**4529 SAND POINT WAY NE**

3035906-LU

Northeast Design Review Board

Recommendation Meeting

ALT 4.2 // LOWER PARKING LEVEL 1 (OF 2)

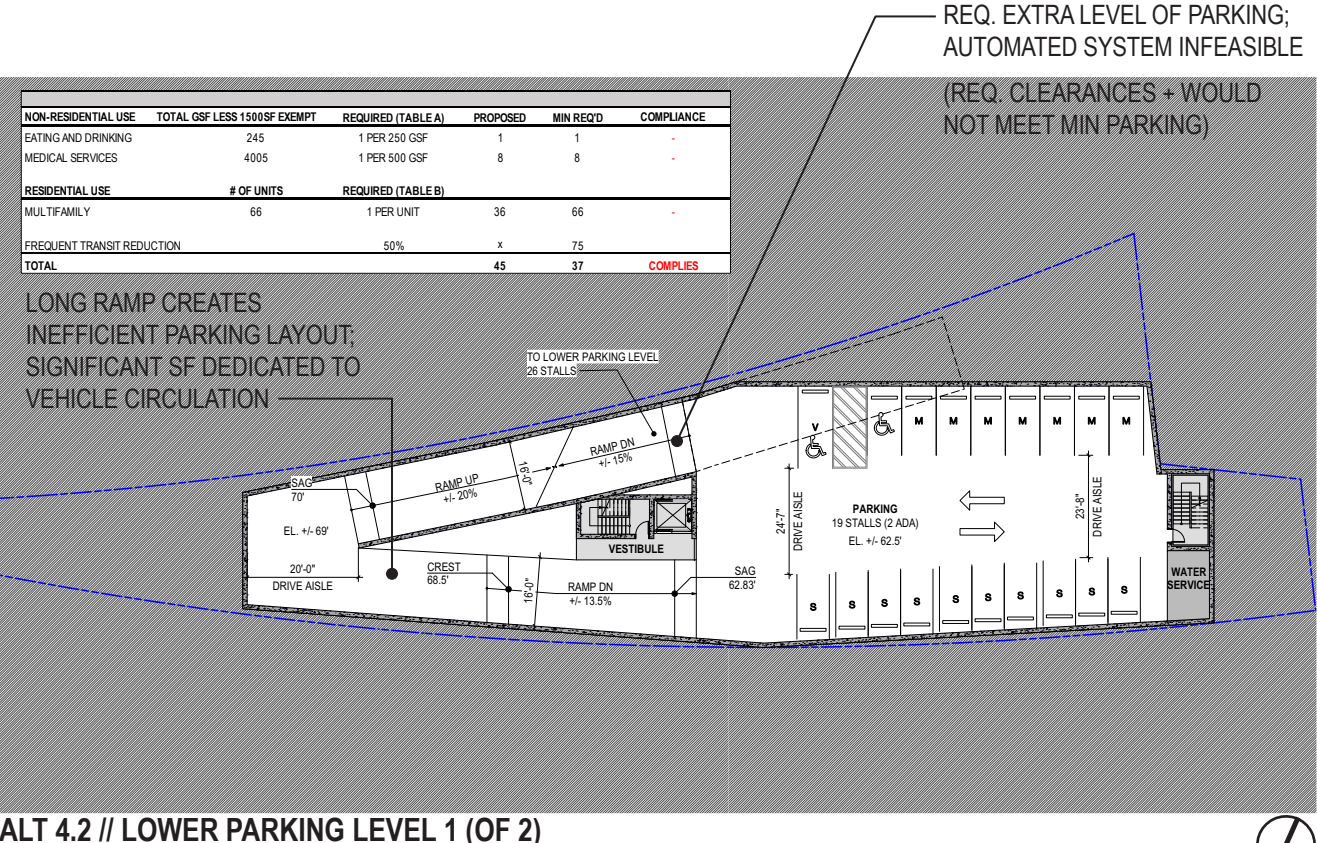
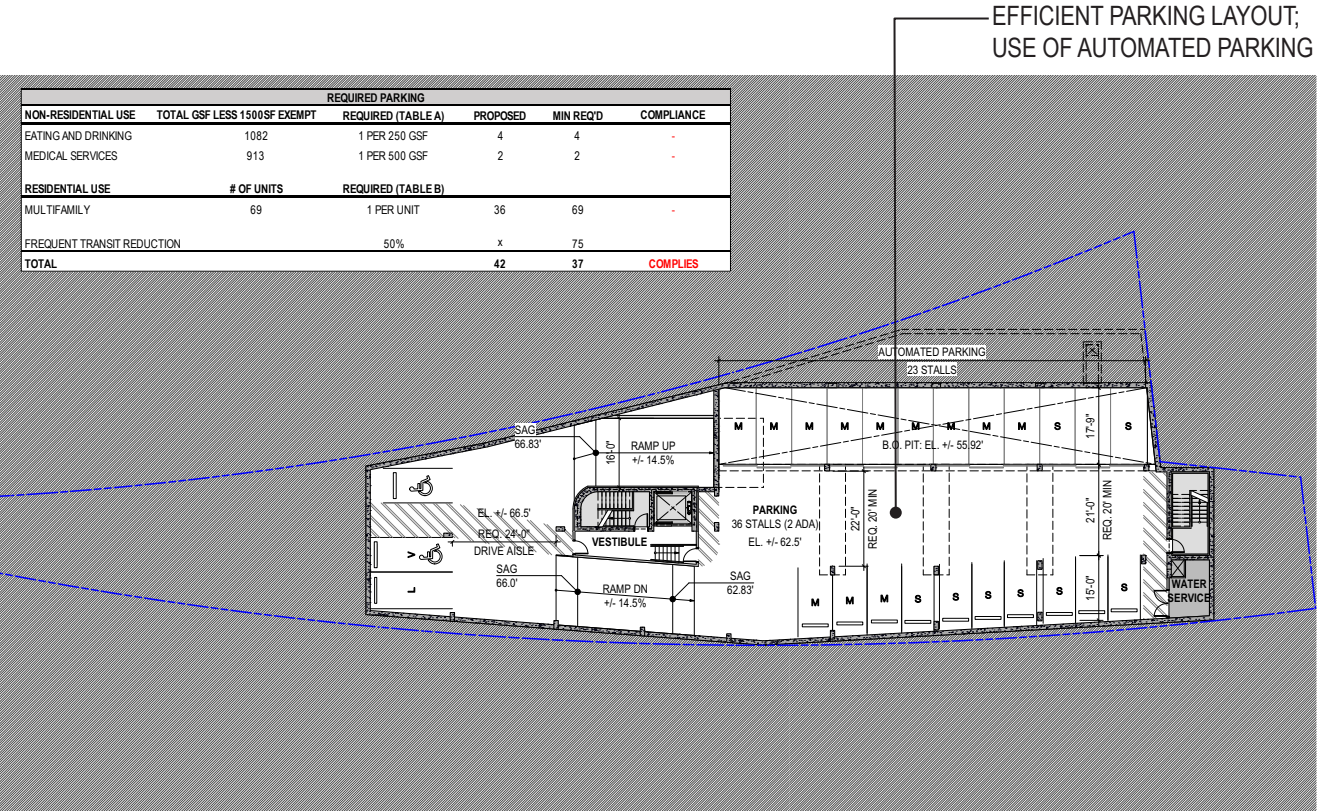
- a. Staff supports Design Alternative 4.2 due to its intent to both preserve the Exceptional tree near the northeast corner of the site and place its driveway access to parking location along 39<sup>th</sup> Ave NE away from the Sand Point Way NE frontage and the corner of the Sand Point NE and 39<sup>th</sup> Ave NE intersection. (CS1-D-1, CS3-A-4, DC1-B-1)

The project has advanced Preferred Alternative 3 which features preservation of the Exceptional Tree and parking access off Sand Point Way NE. Alternative 4.2 was produced at the request of the planner, but was intended to demonstrate how impractical and negatively impactful a large ramp on 39<sup>th</sup> would be to the project. It was not intended to be a viable option.

The program along 39<sup>th</sup> Ave NE in Alt 3 has been developed to be a more active, multi-layered connection to the Burke Gilman Trail while providing a widened sidewalk, covered entry, and landscape buffer. Alt 4.2 would have a street frontage dominated by the parking ramp and BOH program, generating significant blank façade with a poor, vehicular focused relationship to the street and to the Burke that is only 60’ away. Alt 4.2 would require four additional departures.

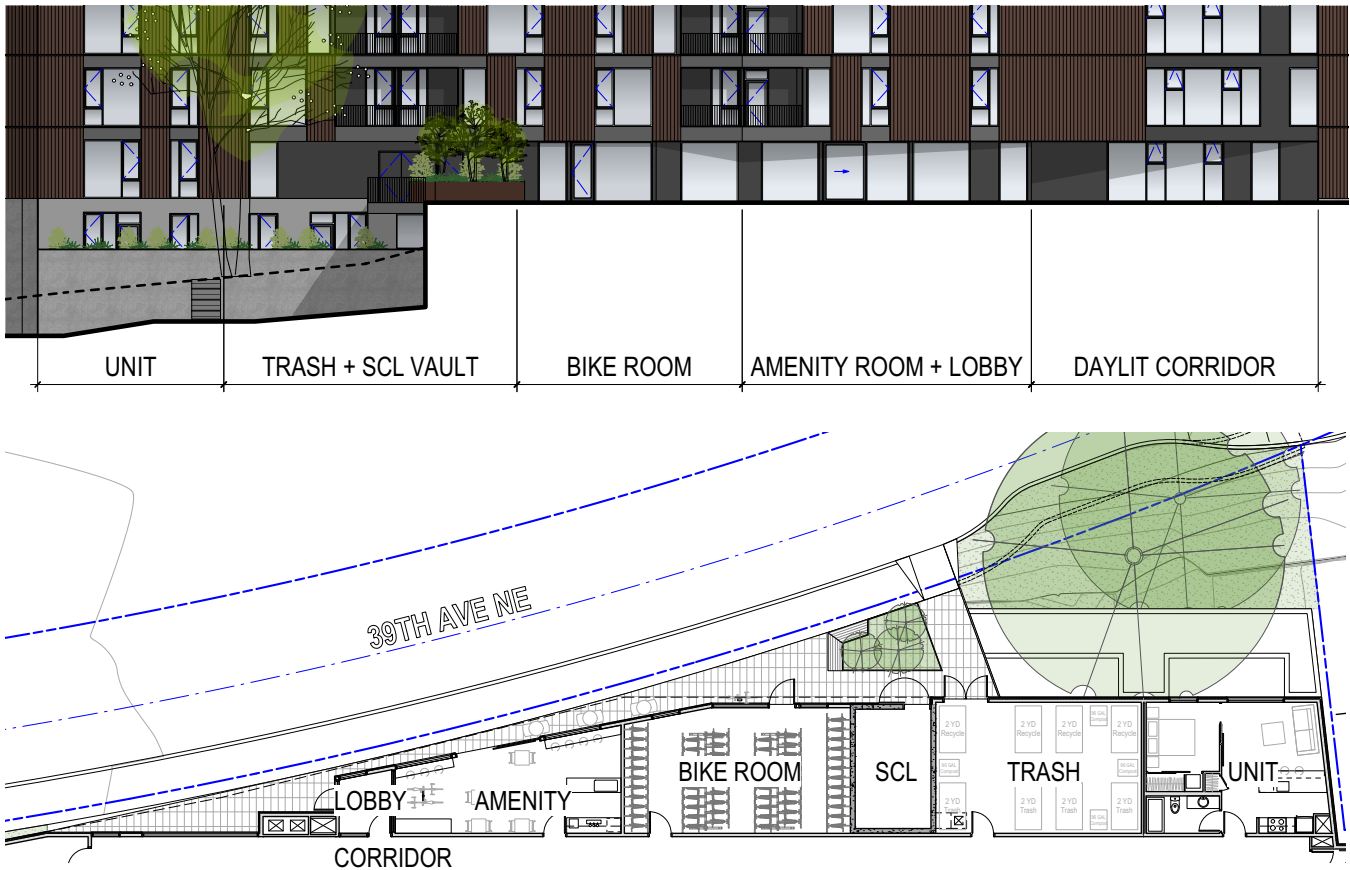
*b. Maintain the grouping of lobby and bicycle storage rooms along 39<sup>th</sup> Ave NE frontage to promote street activation and create visual presence along the 39<sup>th</sup> Ave NE and Burke-Gilman Trail. Ensure that this grouping is visually expressed along the street frontage through contrast in exterior materials and extensive fenestration compared to the service and driveway areas along the same frontage. Consider blending these spaces to allow the residential lobby to encourage pedestrian activity to the bicycle storage space. (CS2-B-2, PL1-A-2, PL1-B-3, DC2-E-1)*

Utilizing the steep grade change up to 39<sup>th</sup> Ave NE, the proposal maintains a secondary residential lobby, a bike lounge / potential bicycle focused commercial space and a substantial bike storage room on level 2 – giving more direct access to the Burke Gilman Trail and activating this street frontage. The service areas have been minimized, generating primary focus on the program elements that relate to the Burke Gilman trail with significant fenestration making a visual connection.

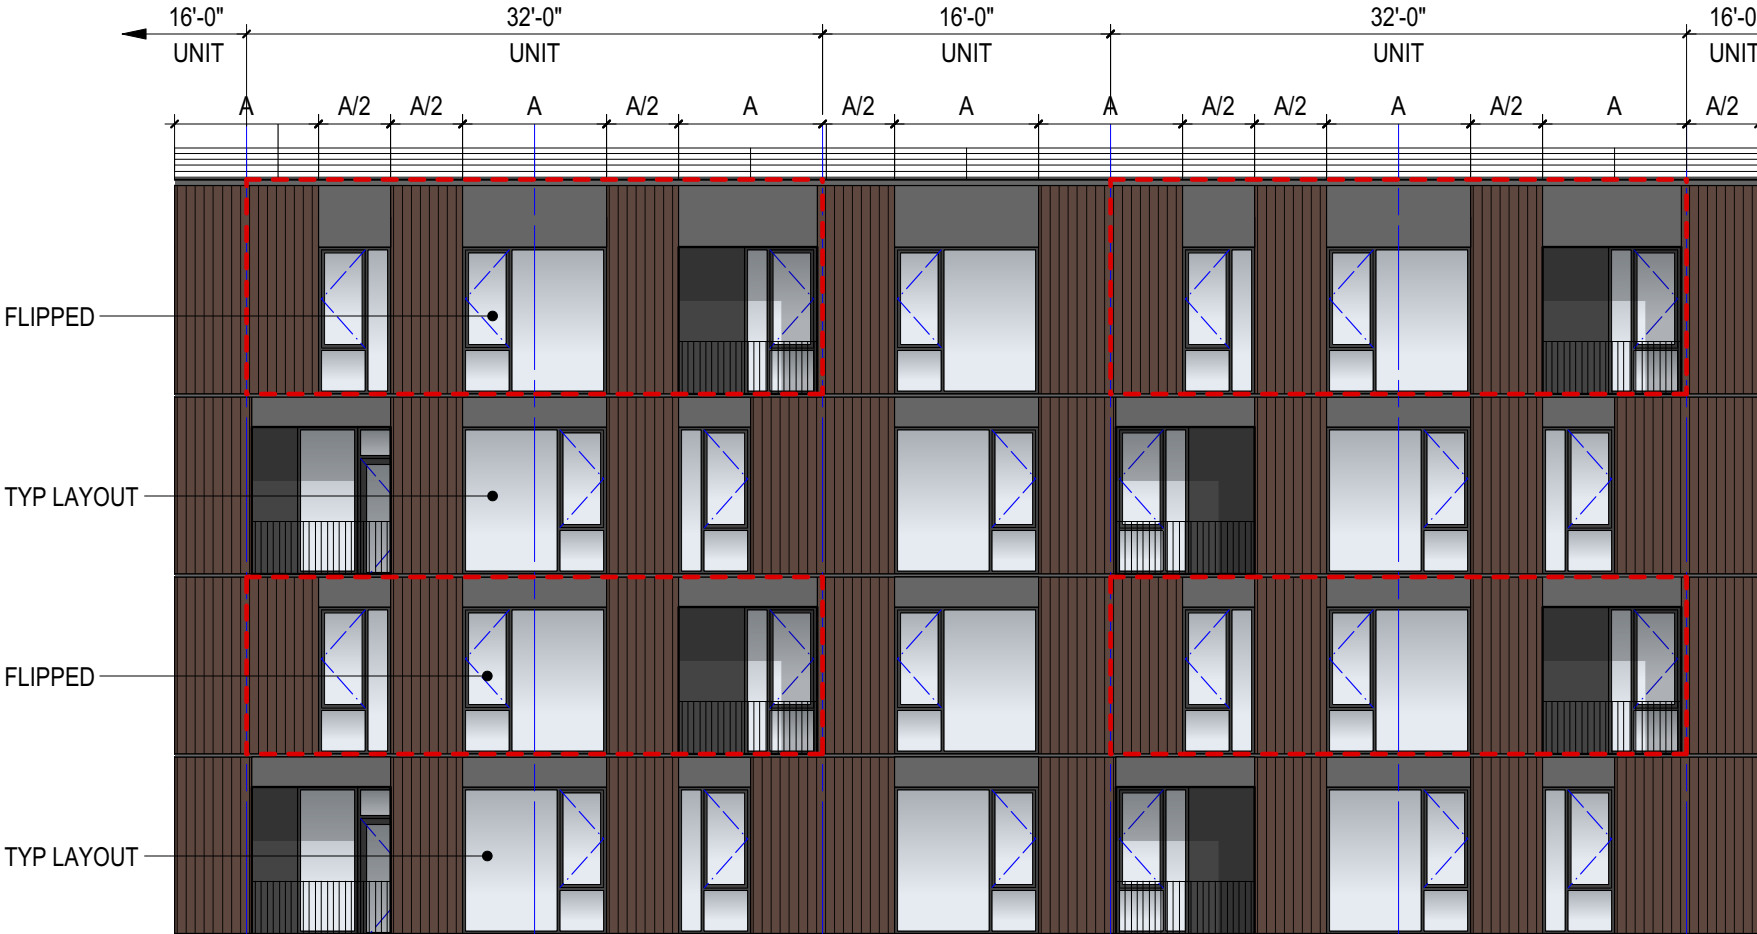
a. *Echoing public comment, Staff agrees with the applicant’s intent to preserve the existing Exceptional tree in the northwest corner of the site. Preservation of this tree will result in better meeting the applicable design guidelines to promote the incorporation of existing site features and natural elements along the 39<sup>th</sup> Ave NE frontage facing the popular Burke-Gilman Trail into the site planning (CS1-D-1, CS2-A-1)*

b. *The Arborist Report submitted with the application indicates that the Madrone tree can be preserved with development of the site, but also describes its likely sensitivity to disturbance, particularly to construction activity within the 39<sup>th</sup> Ave NE right-of-way. Due to its sensitivity to disturbance and its presence on a sloped portion of the site that will be adjacent to both building and street construction, Staff recommend submission of an Arborist Report prepared by a Registered Consulting Arborist with the Master Use Permit and Recommendation packet with a recommendation on the tree viability with development (CS-D-1)*

With the support and expertise of multiple arborists, who have performed several site visits and investigated the root structure of the Madrona, we have planned the building around the preservation of the exceptional Madrona tree in the NE corner of the site. The native tree acts as a natural buffer between the adjacent 8-story multifamily building and reducing the sense of scale and visual impact from the Burke Gilman Trail. Retaining the tree preserves a portion of the site’s natural topography, habitat and open space.

PROPOSAL WITH EAST STAIR PENTHOUSE (EDG MASSING)

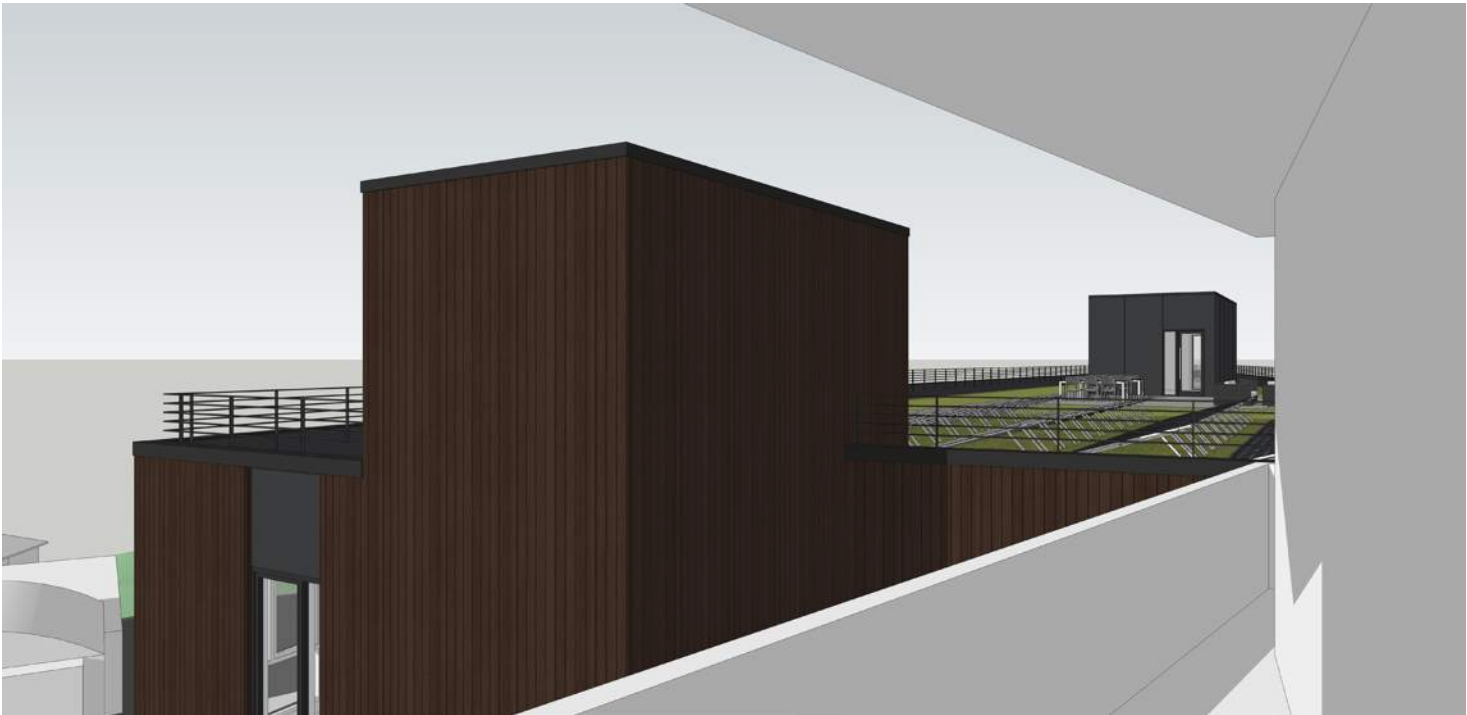
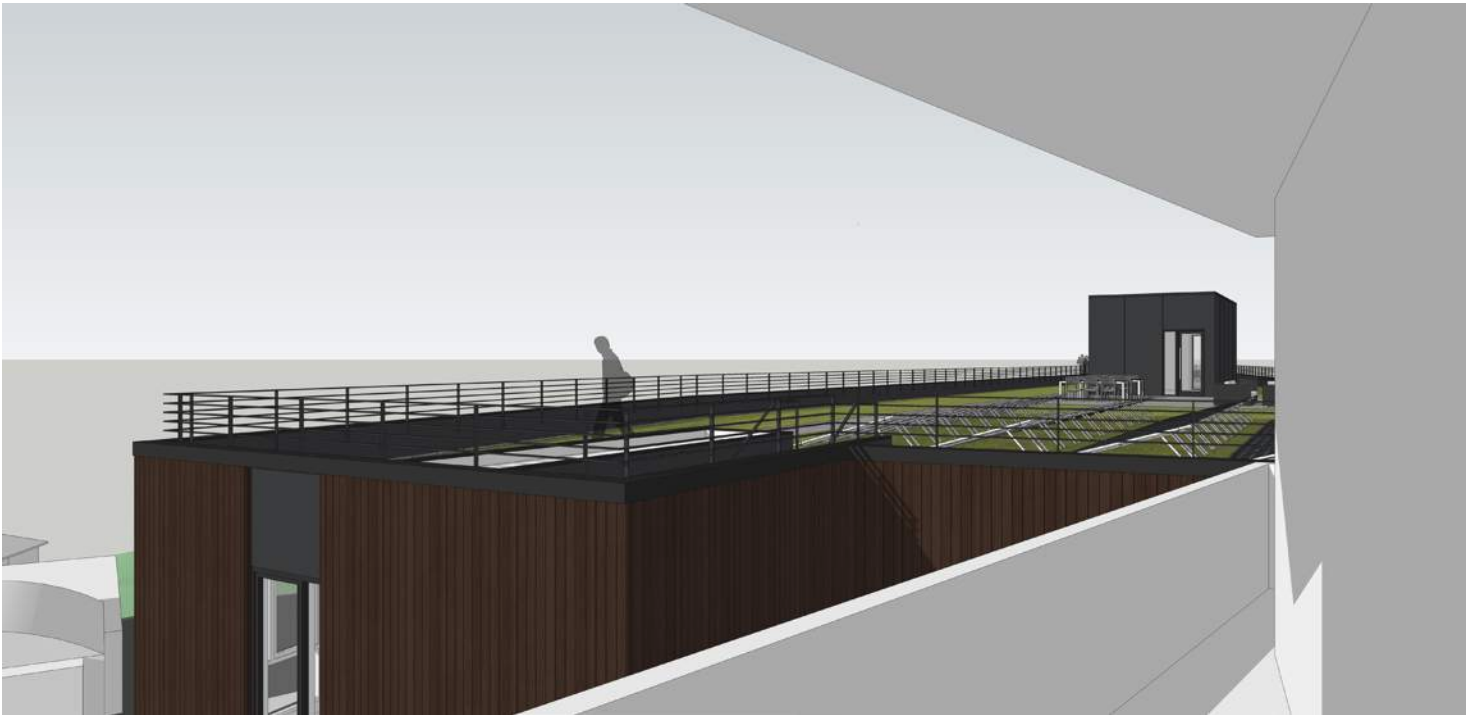
#### MUP COMMENT:

The unusual site geometry results in a jogging property line, interlocking with the adjacent property to the east. An existing landscape easement prevents development in the eastern most portion of the site, preserving light and views for the existing multifamily building to the NE.

By setting the residential levels back to preserve the exceptional tree on the north side, a significant length of property line will be open – maintaining light and air for the existing building while providing a view of the tree and other landscaping.

There are no privacy conflicts with window placement between the two buildings and only a portion of the existing building's corner balconies will be impacted by the proposed building as a result of their vicinity to the property line.

The proposed building's second stair on the east end has been revised to eliminate the need for a penthouse at the roof. The stair is required for egress, but has been detailed to transition from interior to exterior space before reaching the roof – significantly reducing the impact to the existing building as shown on page 34.

SITE PLAN // TREE PROTECTION AREA

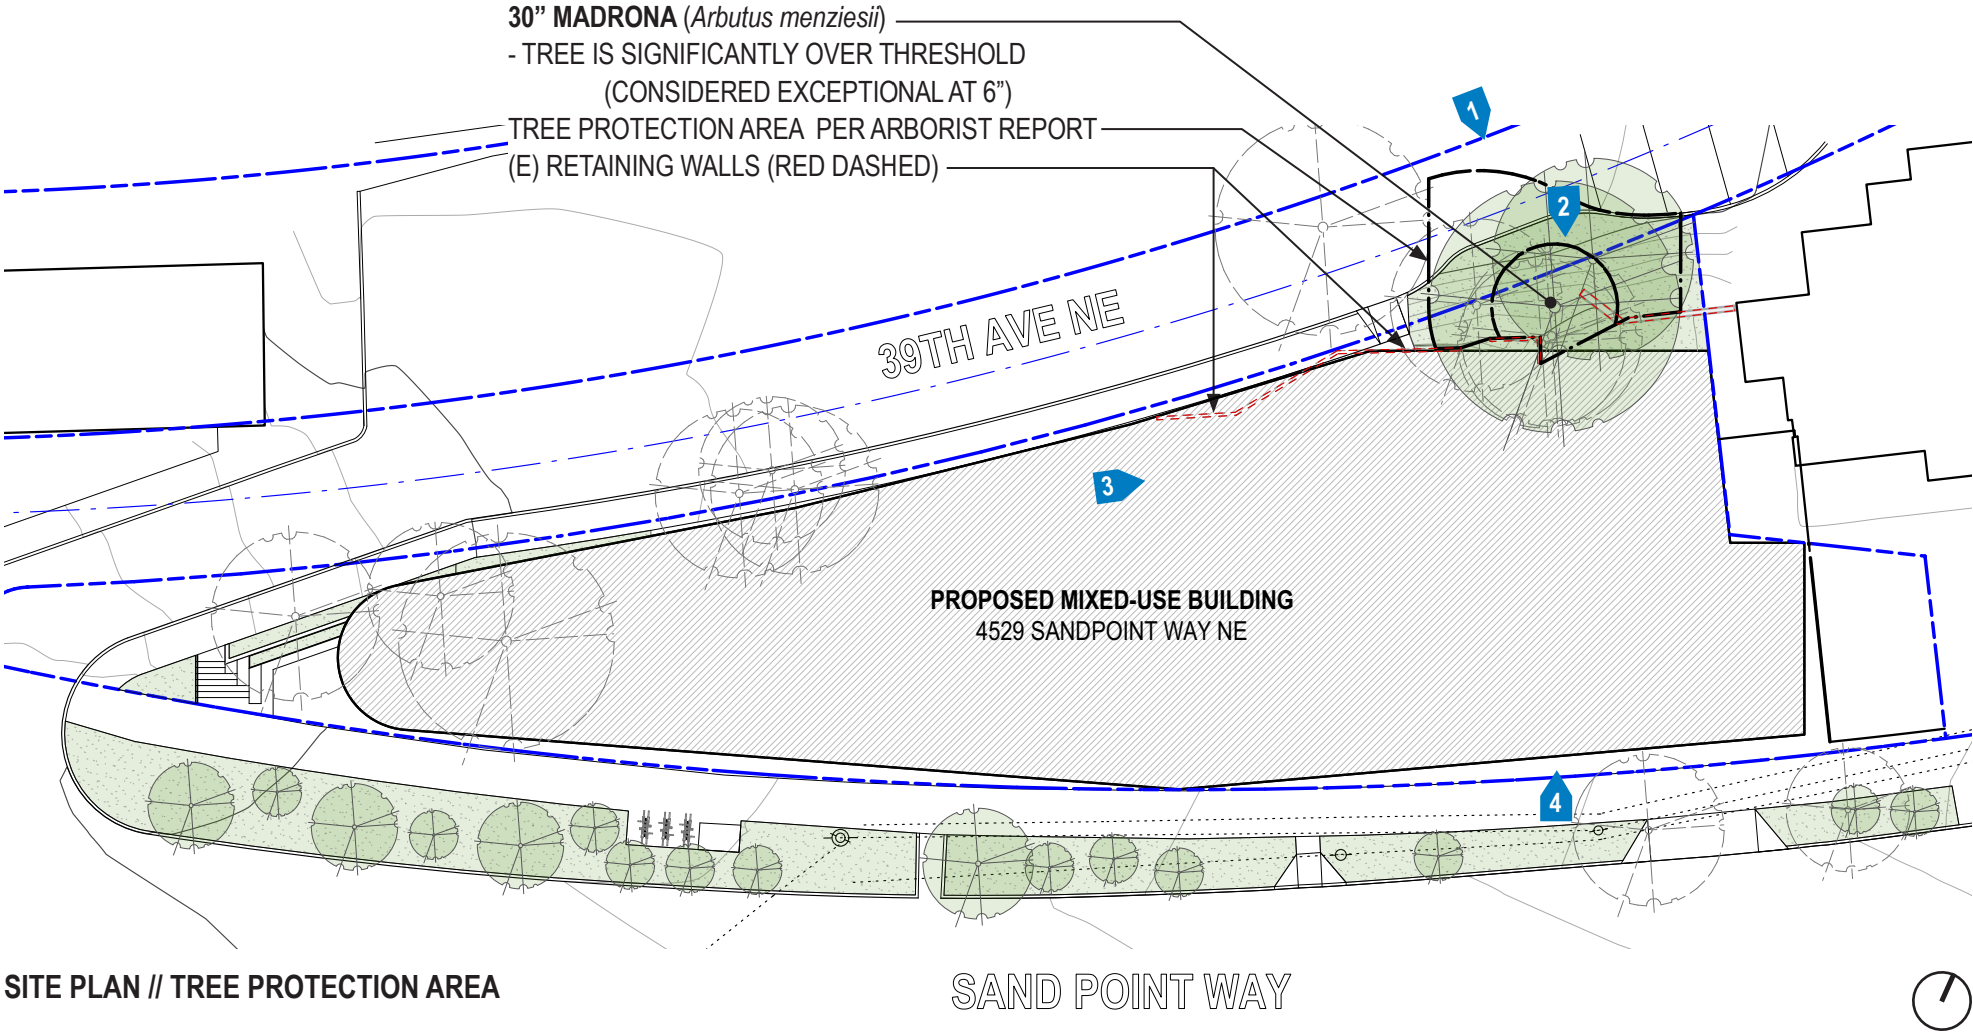
- One attendee inquired whether there was a plan for the trees onsite, and noted that the trees in the back corner have a lot of birds in them.
